Figure 7-7. MPL Propulsion Subsystem Schematic

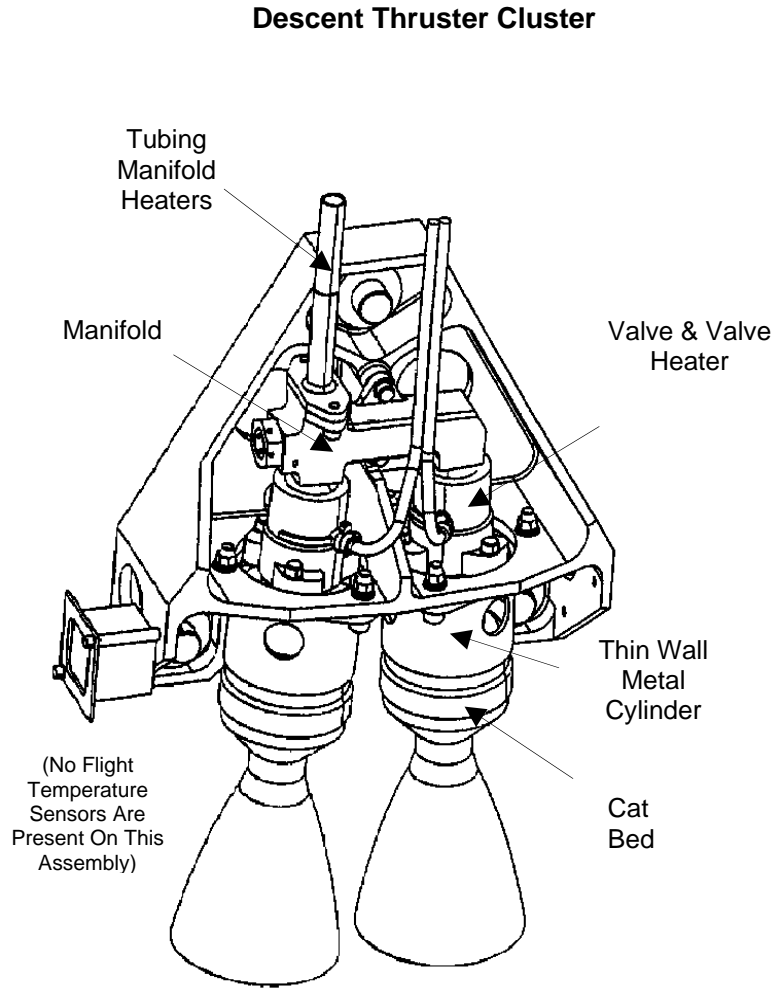
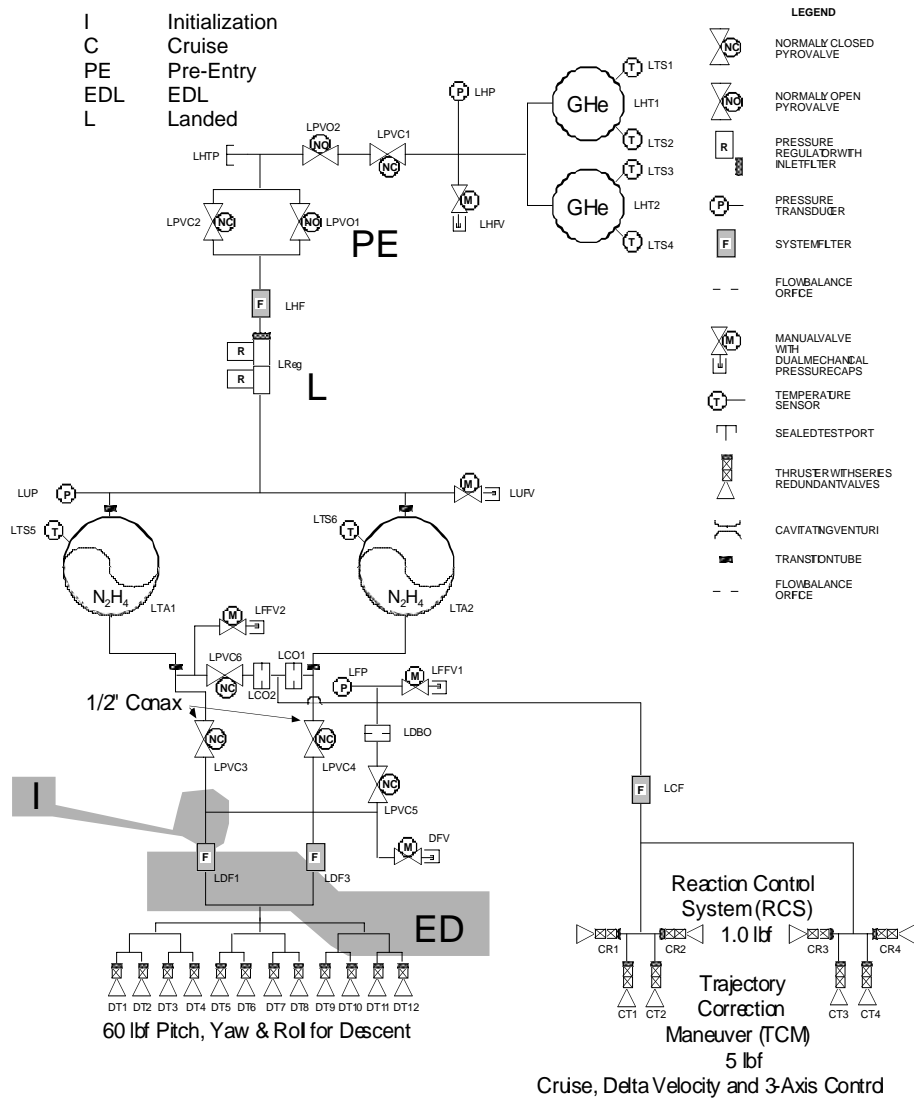
The design approach for balancing flow from the two parallel branches during powered descent increased the risk of exceeding control authority. A statistical process for estimating the allowable flow variation should be used. There was no testing to validate the effects of water hammer on small differences of flow resistance in the two parallel branches. Appropriate margin for uncertainties does not appear to have been added.

If parallel tanks must be used, trim orifices should be incorporated into each parallel branch. If this is impractical, use a conservative statistical approach and add significant margin for unknowns.

Figure 7-8. Touchdown Monitor Functional Flow Diagram

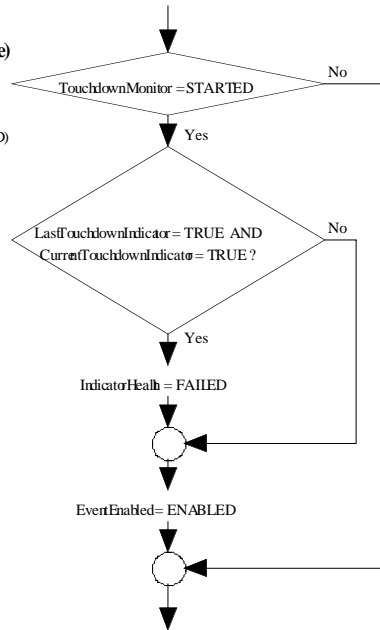
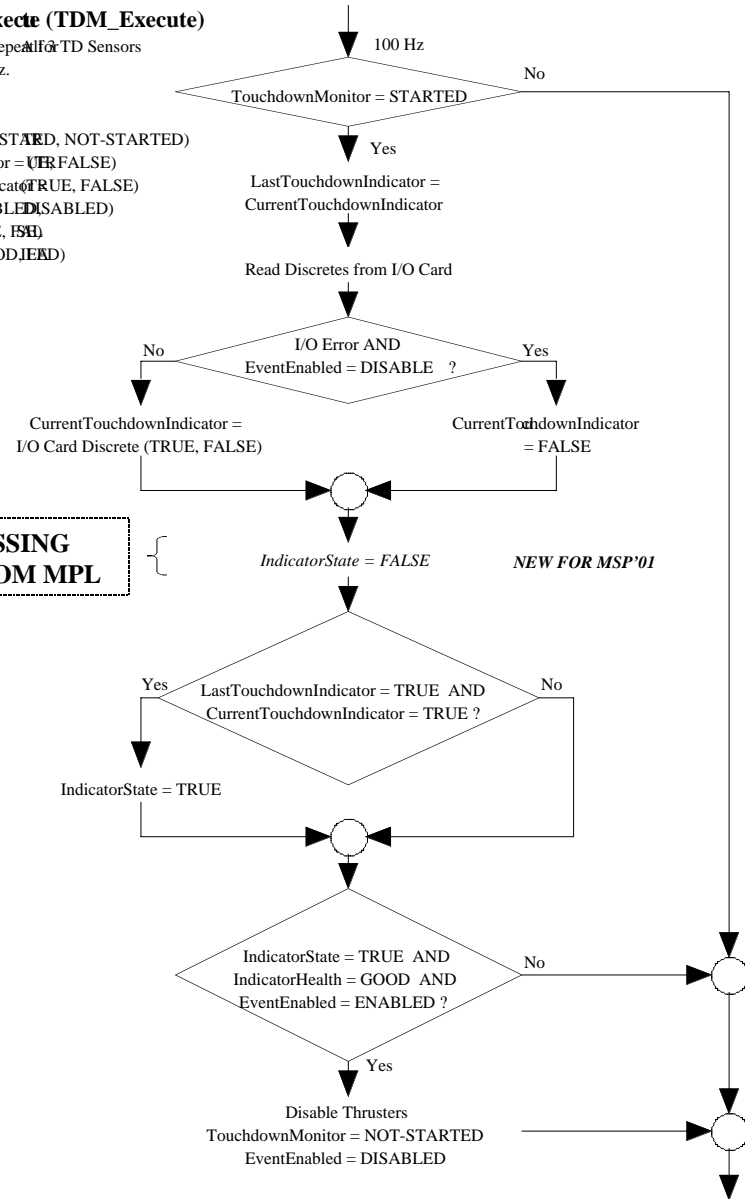
The next step on the diagram shows a line of code (Indicator State = False) that the Mars 2001 program added to correct the logic. That line was not included in the MPL code; therefore, we proceed to the next step. The logic asks if both the Last Touchdown Indicator and the Current Touchdown Indicator are in the True state. If they are, the Indicator State is set to True, which indicates that the sensor in that leg indicates that touchdown has occurred. If the answer is no, the Indicator State is not changed. The sequence then asks whether the Indicator State is true, whether the Indicator Health is Good, and whether the Event Enabled is Enabled. If the responses to those questions are yes, Descent Engine Thrust Termination is commanded. If any of those states are not satisfied, the logic returns to the beginning of the Touchdown Monitor Execute (TDM_Execute) and the process repeats.

When the Radar senses that the 40-meter altitude has been reached, the flight software commands the Touchdown Monitor Enable (TDM_Enable) to start (shown at the bottom left of Figure 7-8). The first step checks the state of the Touchdown Monitor, which has already been initialized to the Started

state. The logic then continues to the next step, where it asks if the Last Touchdown Indicator and the Current Touchdown Indicator are both set to the True state. If that is so, the Indicator would have turned on erroneously before the 40-meter altitude was reached; therefore, the logic sets the Indicator Health to the Failed state. If the answer to the logic is no, the Indicator Health state is not changed from Good to Failed. The next step is to set Event Enabled to the Enable state, thereby indicating that the 40-meter altitude has been reached. The software then returns to the Touchdown Monitor Execute (TDM_Execute) sequence shown at the right side of Figure 7-8. The logic continues to repeat this sequence until any of the three touchdown sensors has two consecutive True readings. If the Indicator Health is Good (since the Event Enabled would now be Enabled), the Engine Thrust Termination command is issued. The Touchdown Monitor state is changed to Not Started and the monitor sequence is ended.

IndicatorState = FALSE **NEW FOR MSP'01**
